REMARKS

Applicant has reviewed the Office Action mailed on June 23, 2005 as well as the art cited. Claims 33-37 have been cancelled without prejudice or disclaimer and Applicant reserves the right to reintroduce them in a continuation application at a later date. Claims 4, 17, 18 and 38 have been amended, claims 7, 9, 19-32 and 42-43 have been withdrawn from consideration and claims 44-48 have been added. No new matter has been added. As a result, claims 1-6, 8, 10-18, 38 and 44-48 are currently pending in this application.

FIG. 6

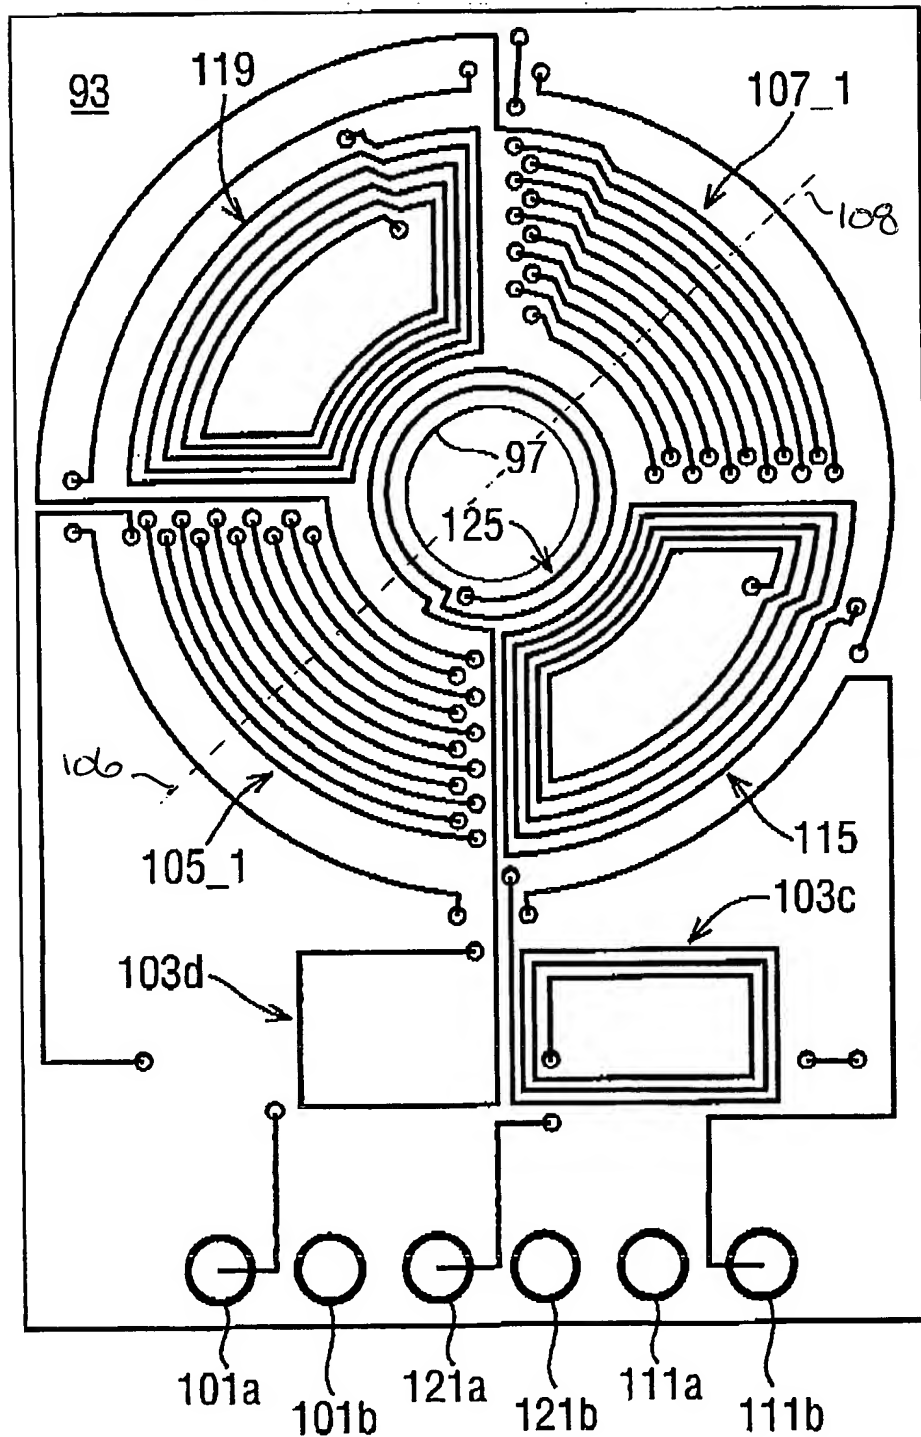
Red-lined Figures are included in attached sheets of Fig(s). 6 and 7. These sheets, which include Figs. 6 and 7, indicate the changes.

Specifically, in response to the objections set forth in the present Office Action, enclosed are Replacement Sheets 5/14 and 6/14 in which a first radial axis 106 and a second radial axis 108 within the plane of the PCB 91 and a first axial axis 114 and a second axial axis 118 perpendicular to the plane of the PCB 91 have been shown. Furthermore, the specification has been amended to conform with the amended drawings. No new matter has been added.
